**Response to U.S. EPR Design Certification Application RAI No. 437, Supplement 7**

**Request for Additional Information No. 437(4953), Supplement 7, Revision 1**

**U. S. EPR Standard Design Certification**

**SRP Section: 06.02.01 - Containment Functional Design**

**Figure 06.02.01-101-1—Hydrogen Mixing Damper**

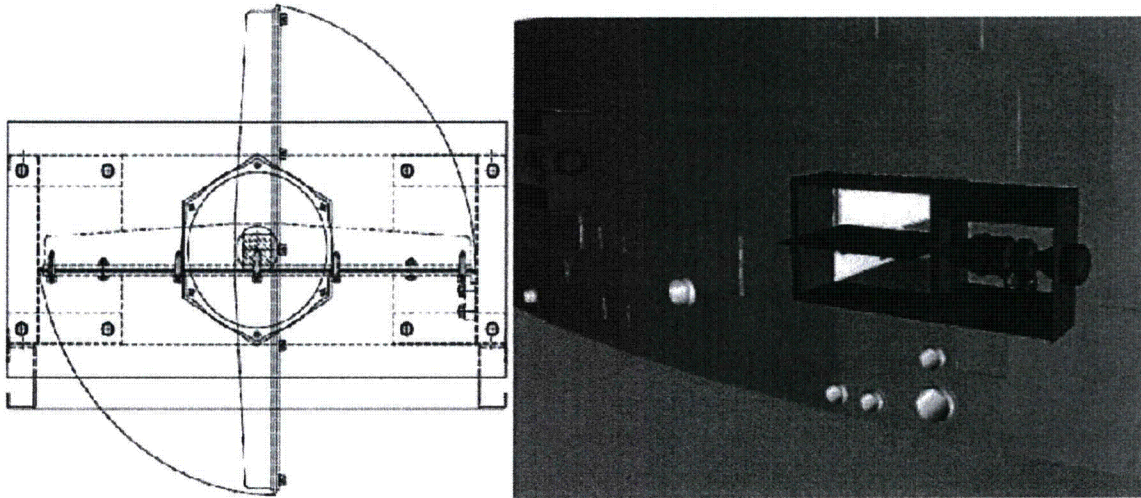
Supplement 1 response indicated that the rupture foils would not open for a MSLB in the accessible space. The temperature and pressure in the equipment room was calculated to remain at the initial value until 18 seconds into the event when the mixing dampers were assumed to open. With the equipment space isolated from the rest of the containment for the first 18 seconds, the pressure in the accessible space spiked upward rapidly. The staff's understanding is that the foils are designed to rupture on a differential pressure in either direction. At 18 seconds into the event the differential pressure is approximately 50 psid.

- a. Provide the reverse differential pressure for which the foils are expected to open.
- b. Provide the test results demonstrating the foil's opening capability. When will this test data be available to the NRC staff?
- c. If the foils do not open, by 18 seconds when the dampers are assumed to open there will be a very large differential pressure for them to open against. Provide justification that the dampers can open against this differential pressure.
- d. If the damper opening time is increased slightly and the foils are not open, the containment design pressure will be exceeded. Discuss the uncertainty in damper opening time and justify that the containment design pressure will not be exceeded.

- b) The July 14, 2011, response to RAI 468, Supplement 1, Question 06.02.02-83 addresses this question.
- c) In the main steam line break (MSLB) analysis with breaks outside of the steam generator (SG) compartment, the foils were not allowed to rupture on a differential pressure. This is an added conservatism in the model and does not reflect the expected behavior of the foils. Because of the design of the dampers, they will still open against a high differential pressure. The rotation axis for the dampers is in the middle of the opening, so any resistive rotational force from a high differential pressure is negated by an equal and opposite opening rotational force. Figure 06.02.01-101-1 shows how the dampers will open.

- d) The dampers are designed with a minimum opening delay time of seven seconds and a maximum delay opening time of 18 seconds. The GOTHIC containment model uses the most conservative value of 18 seconds as the delay opening time.
